Date: November 1, 2022

Subject: ADDENDUM #3

Project: Transition Building
(T99) Addition

Project No: 220081

DRAWING NO. SWK-01

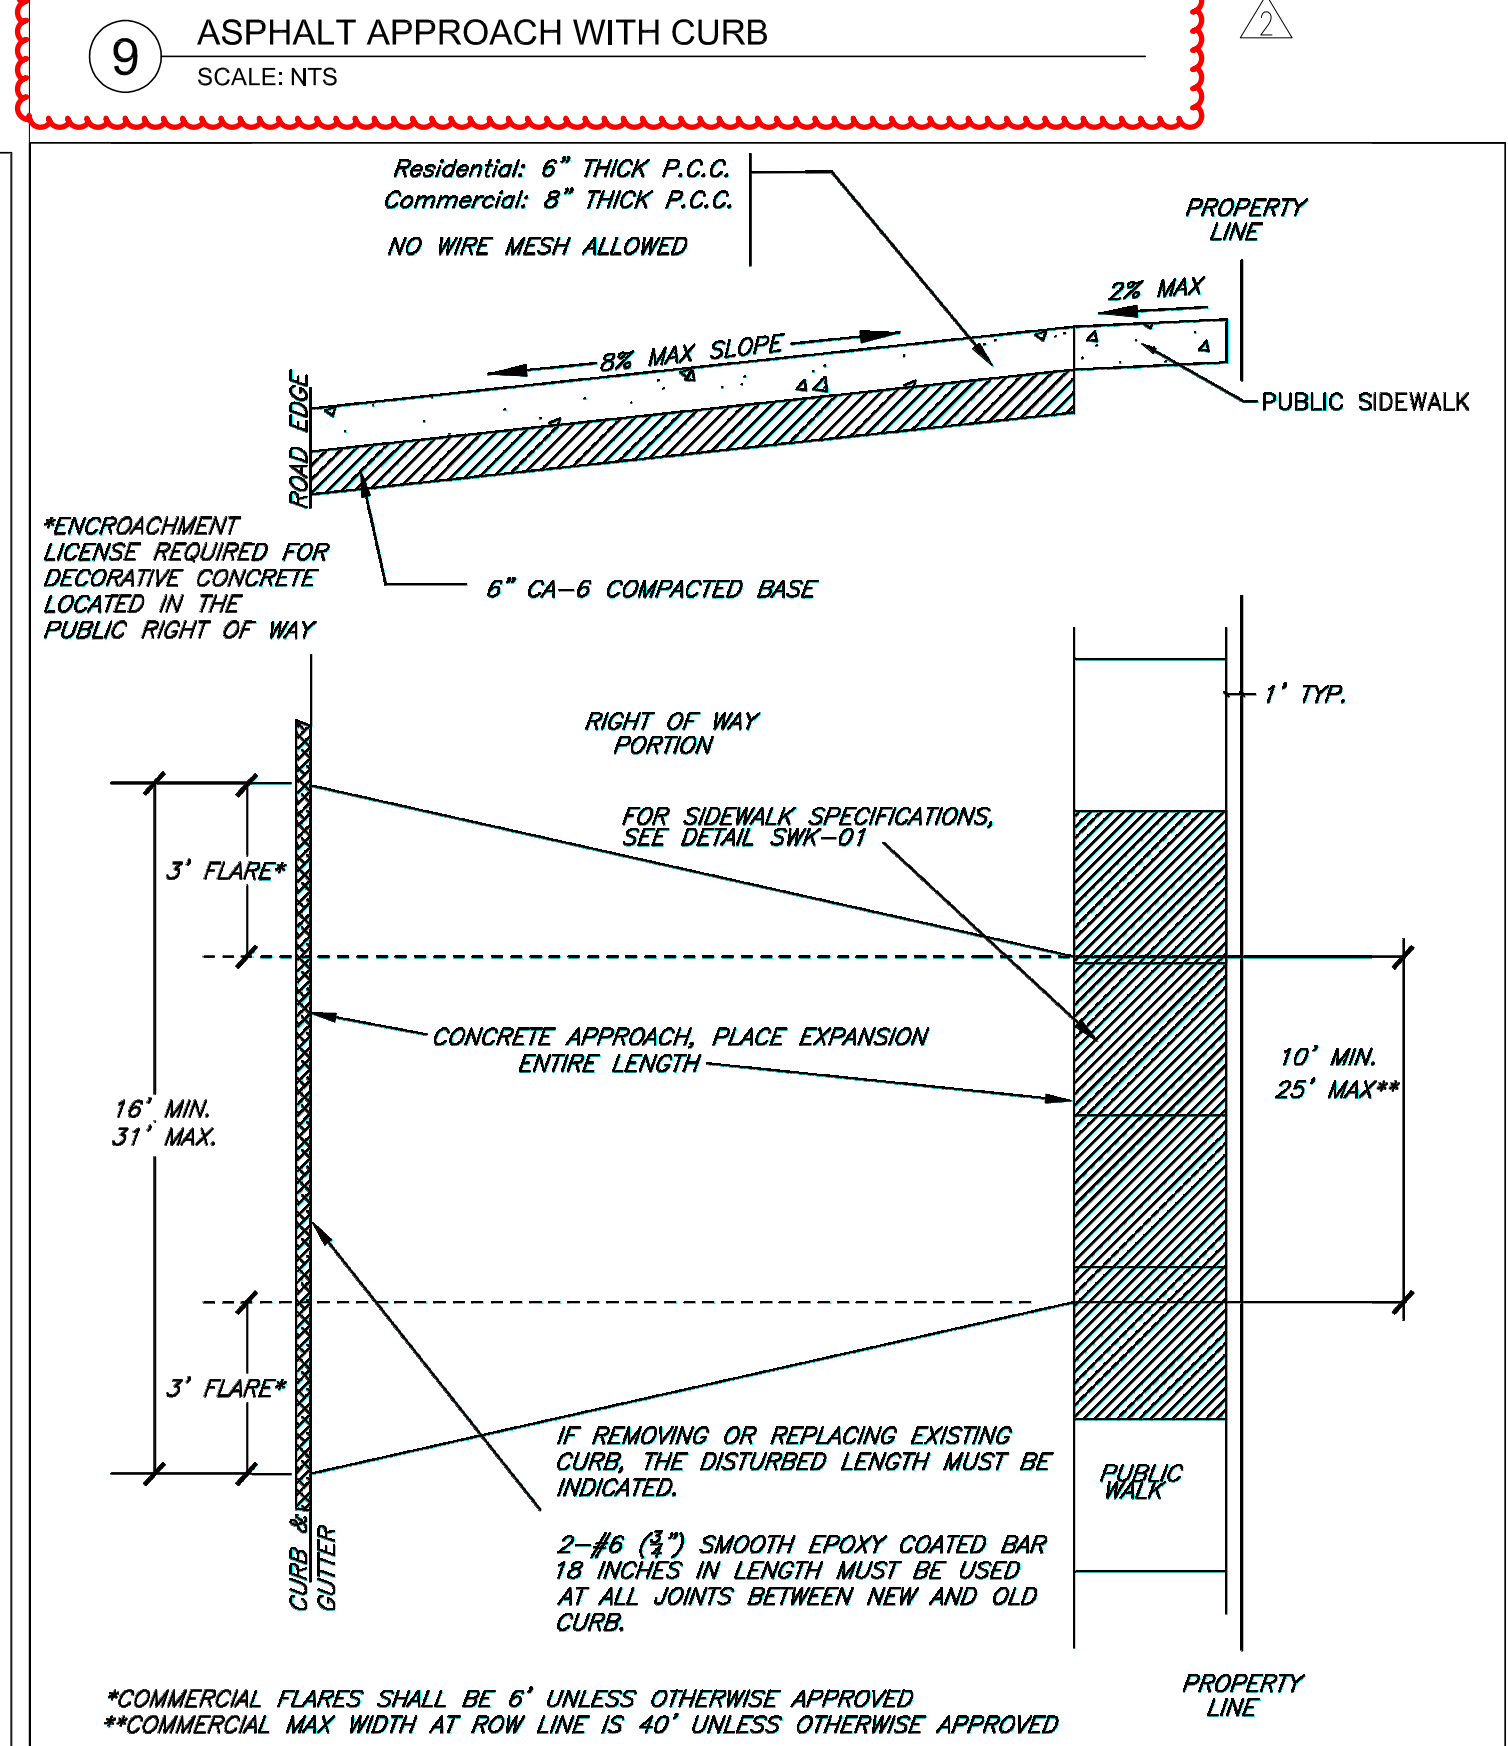
7. ***SHEET C5.00*** (FULL SIZE SHEET REISSUED)
 - Detail 9 has been updated.

CIVIL DETAILS
 Project Number: 220081
 Drawn By: EN
 Sheet: **C5.01**

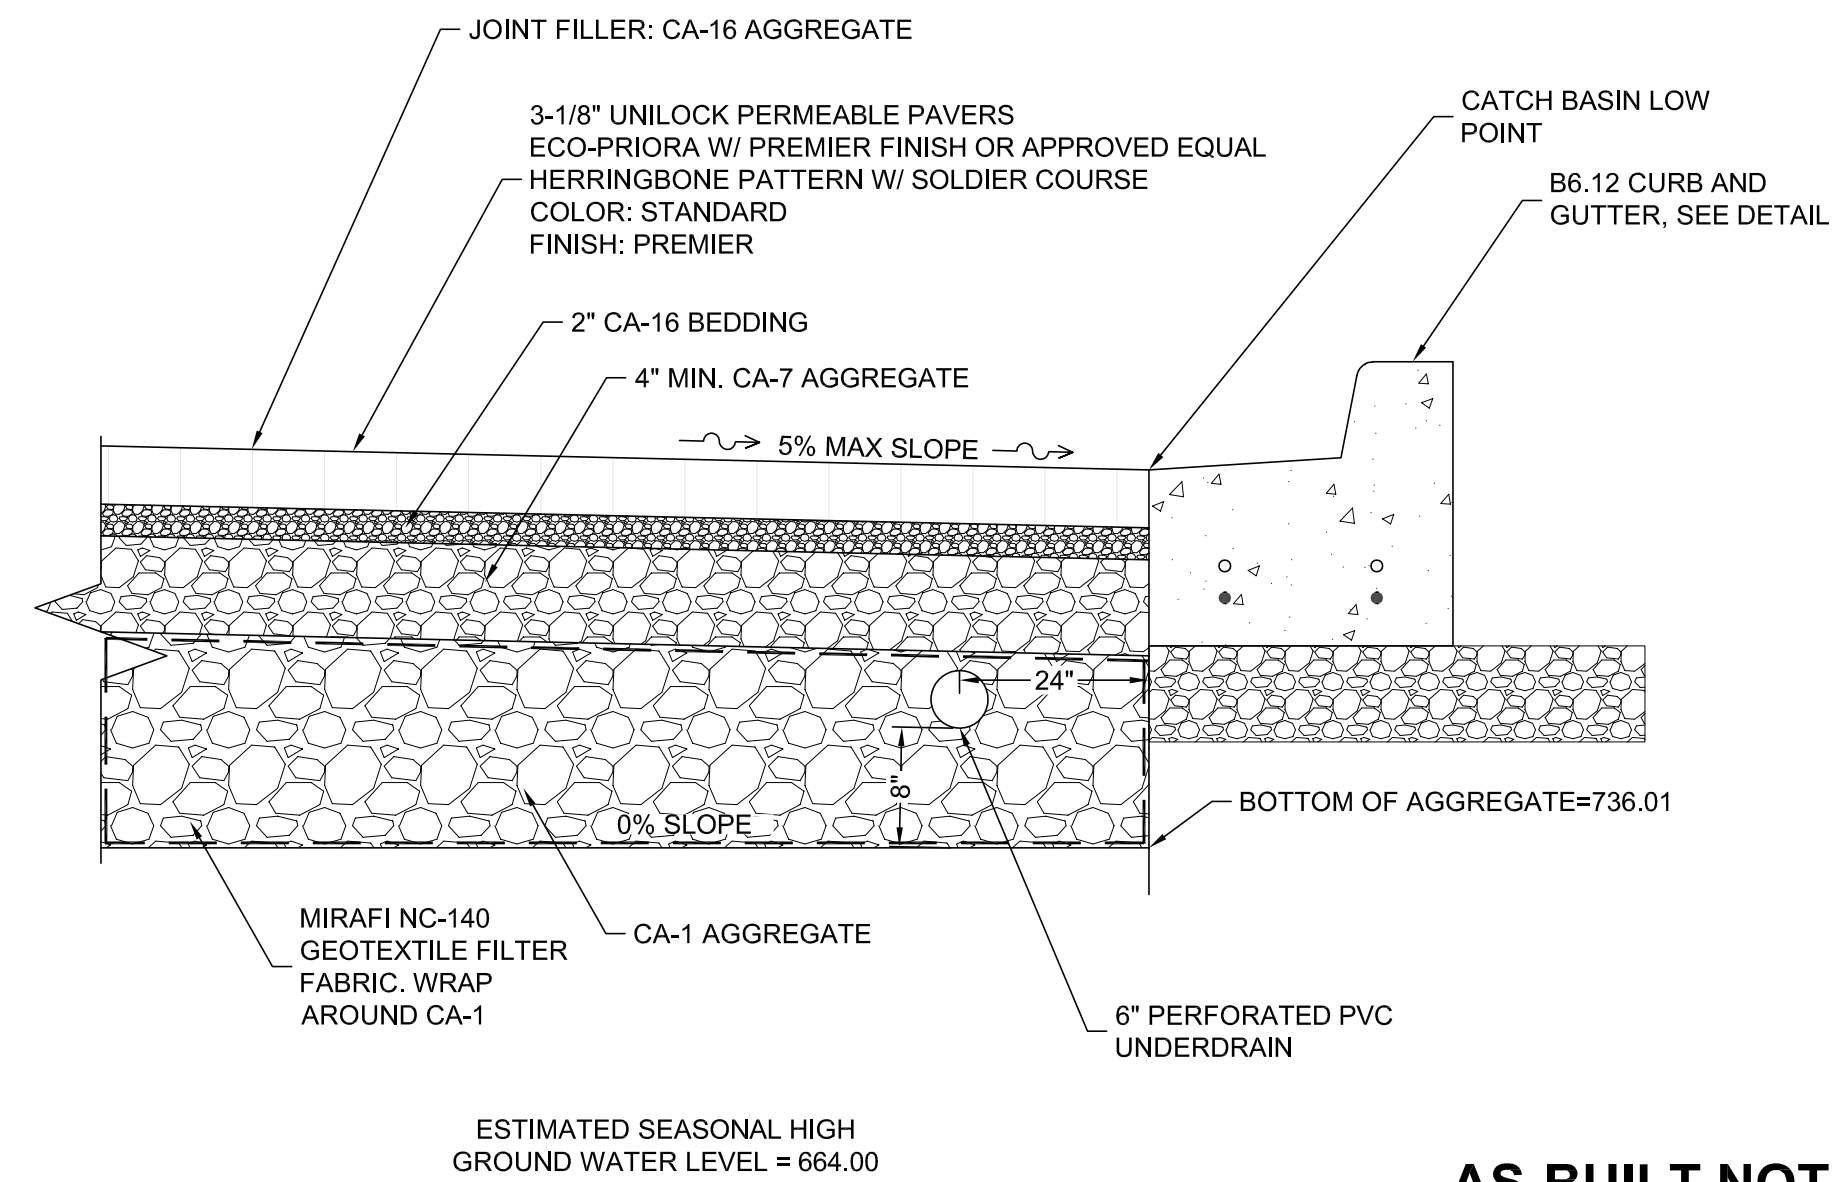
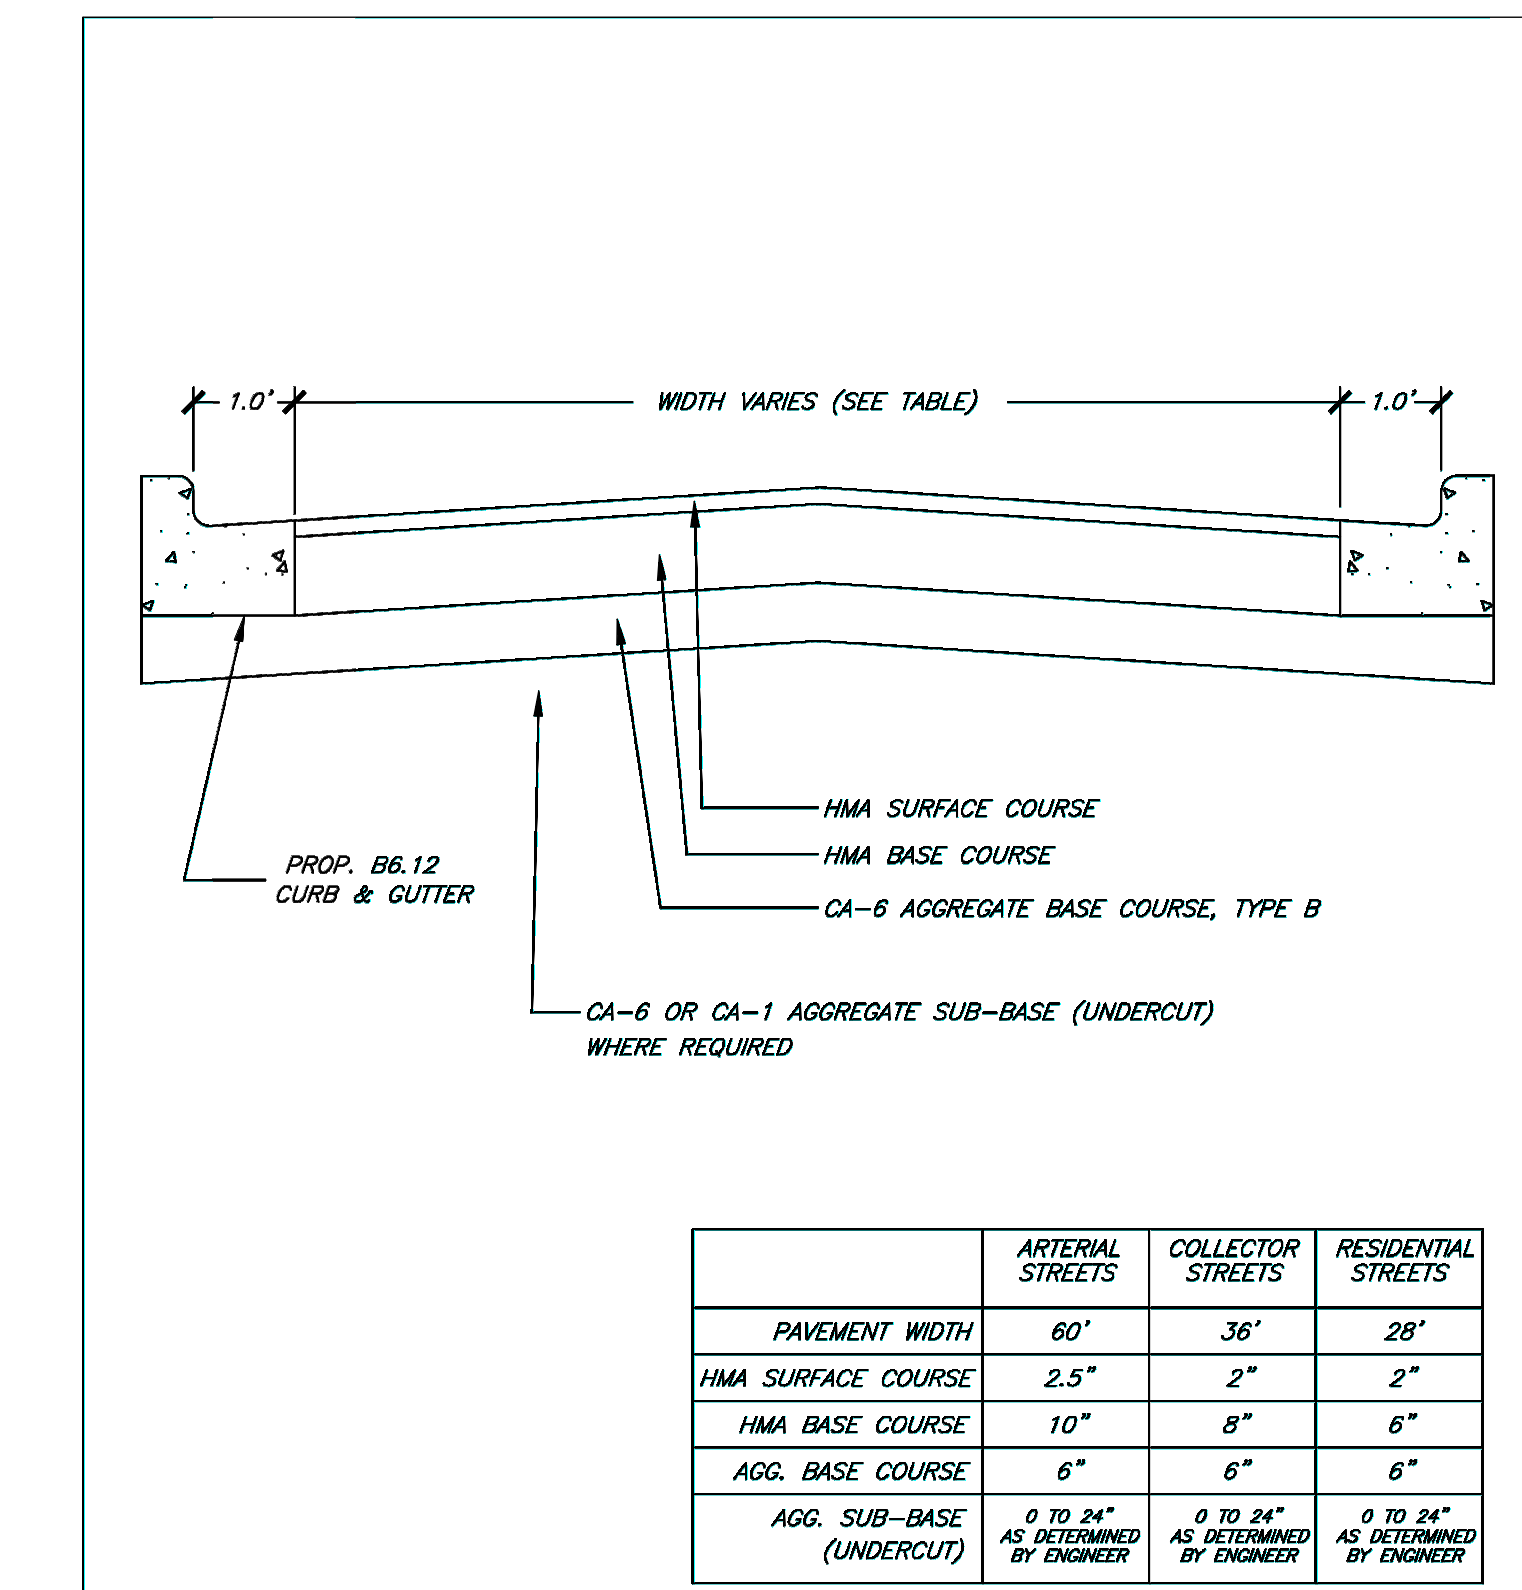
8. ***SHEET C5.01*** (FULL SIZE SHEET REISSUED)
 - Details 2 and 4 have been updated.

5 STONE INFILTRATION TRENCH
 SCALE: NTS

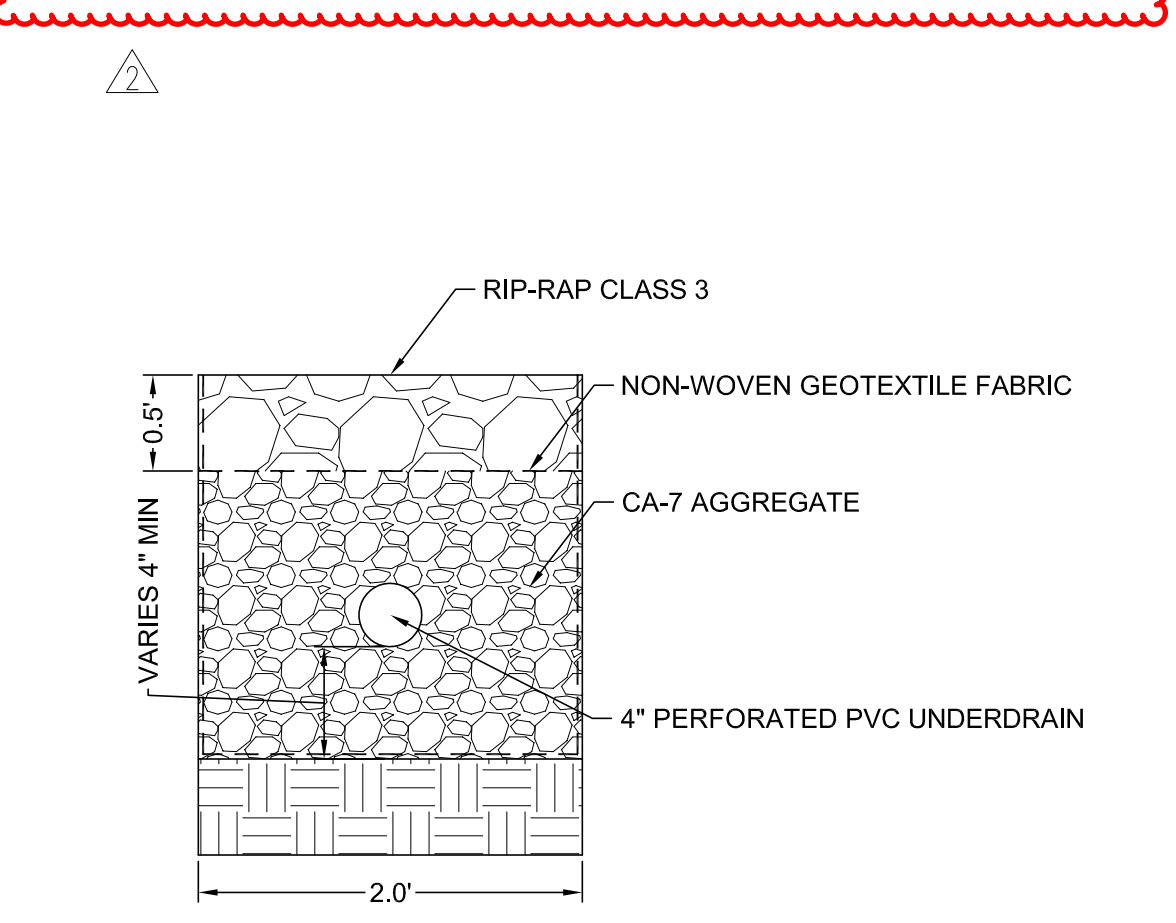
9. ***SHEET C5.02*** (FULL SIZE SHEET REISSUED)
 - Detail 5 has been updated.
